Town of Parker Community Development Department  
Development Review Division  
Attention: **Stacey Nerger**

Application Type: **Replat**  
Status: **First Referral**  
Application Name: **Parker Auto Plaza F1 AMD 2**  
Case/AP#: **SUB20-0025**  
Referral Received: September 25, 2020  
Comments Due: October 23, 2020

Review date: **September 30, 2020**  
Plan reviewer: **Randall L. Capra, [rcapra@parkeronline.org](mailto:rcapra@parkeronline.org)**  
Phone: 303.805.3169

**TOWN OF PARKER FIRE/LIFE SAFETY:**

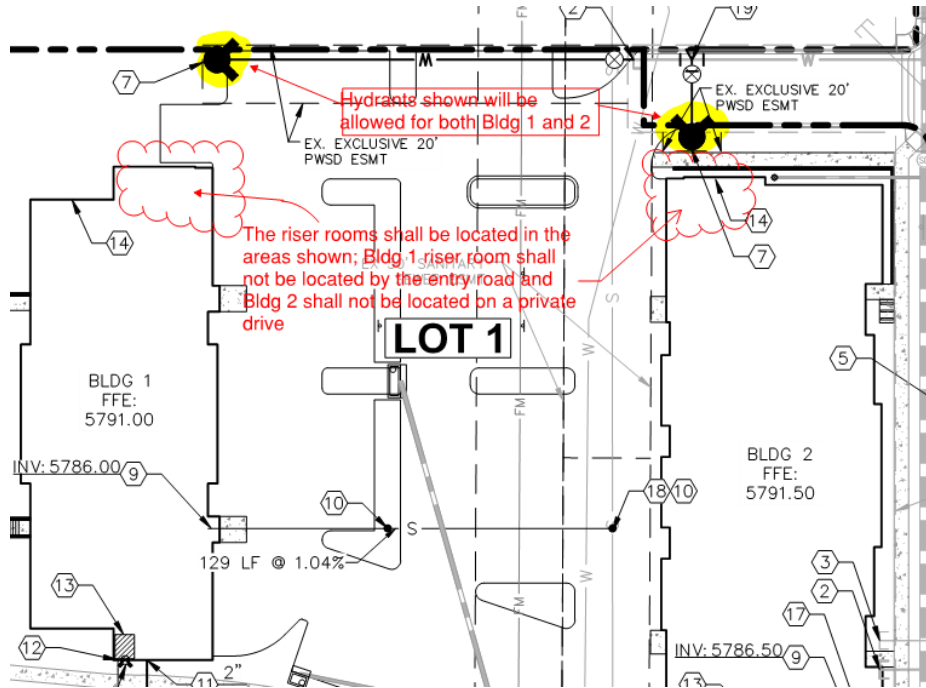
4. The location of the riser room for all three of the four proposed buildings is not acceptable; the applicant was provided with guidelines in as to approved locations in our pre-application meetings and as such, will be required to revisit the submittal. Bldg 1 riser room location is not acceptable by the main entry and Bldg2 and Bldg 3 are not allowed to have the riser room located on a roadway... even if the access is a private road. Additionally, the

applicant will need to identify the location of the fire sprinkler control valve room (more clearly showing its location), provide additional fire hydrants, and ensure the following:

- Exterior access is required into the riser room with access in the building provided either adjacent to the riser room or through the riser room. Access into the fire riser room shall not be through the volley ball court.
- The FACP will be required to be located in the fire sprinkler control valve room; ensure that the riser room is sized to accommodate the FACP and the riser. **A three-foot clearance is required in front of the FACP as well as the sprinkler riser.**
- The underground shall enter the building and turn up no further than 24 inches from foundation wall.
- The FACP shall be located on an interior wall.

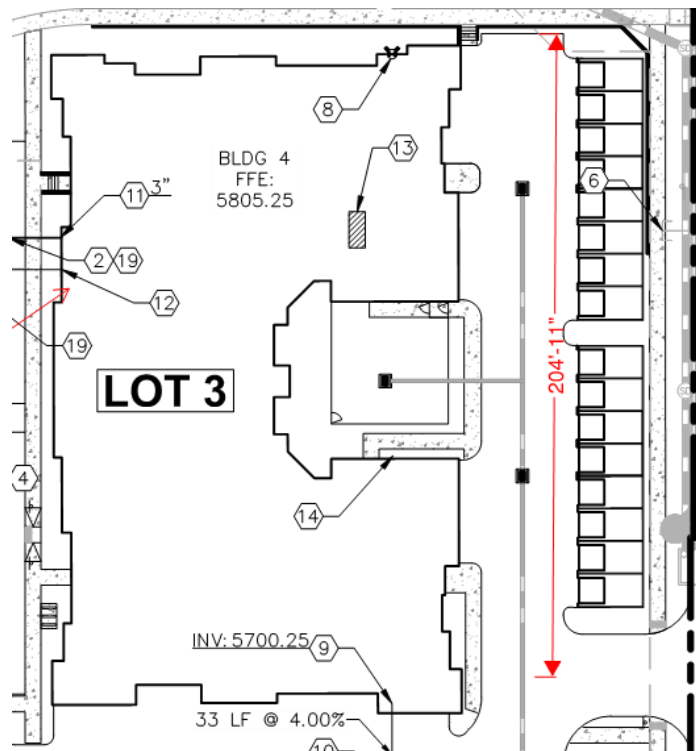
7. The applicant has provided an access road that exceeds 150' on the east side of Lot 3, Bldg 4; this access, as measured from the center line of the access perpendicular to this drive, is approximately 205 feet long. The applicant shall revisit the drive and configure the site to ensure that a dead end is not created that exceeds 150 feet, as required per [18 IFC 503.2.5]. Address this issue when resubmitting.
